### HOLLAND ATLAS Landing Gear

#### Product Change Notice for ATLAS Series Landing Gear Cross Drive Shaft Connection

Effective February 14, 2018

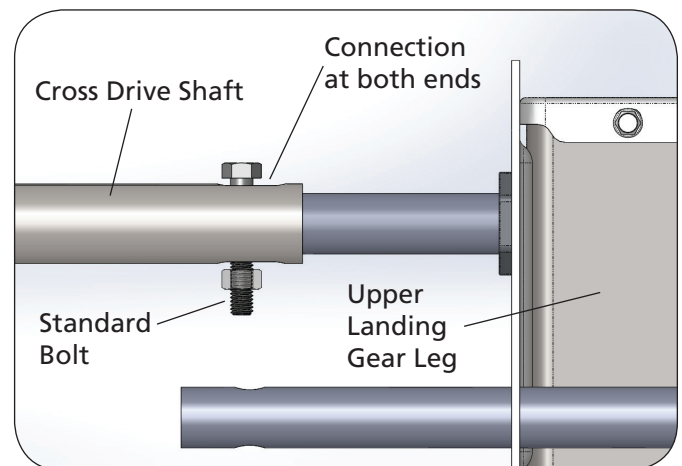
SAF-HOLLAND® has made a product enhancement to the ATLAS Series landing gear cross drive shaft connection fastener

Applicable to all ATLAS Series landing gear, which includes the following models: ATLAS 55/GD60, ATLAS 65/GD65, ATLAS iM and ATLAS 55 FG. This product will be enhanced with the replacement of the old style standard threaded cross drive shaft connection bolt with a new style long shank bolt. This connection bolt change will prevent the cross drive shaft connection from being over tightened which could lead to binding during cranking of the landing gear. The new style long shank bolt, when fully tightened with the lock nut to the proper torque spec (30 ft. lbs.), should allow the necessary side-to-side movement within the cross shaft slots on both ends.

This product enhancement will facilitate proper OEM installation and will not impact fit, form or function.
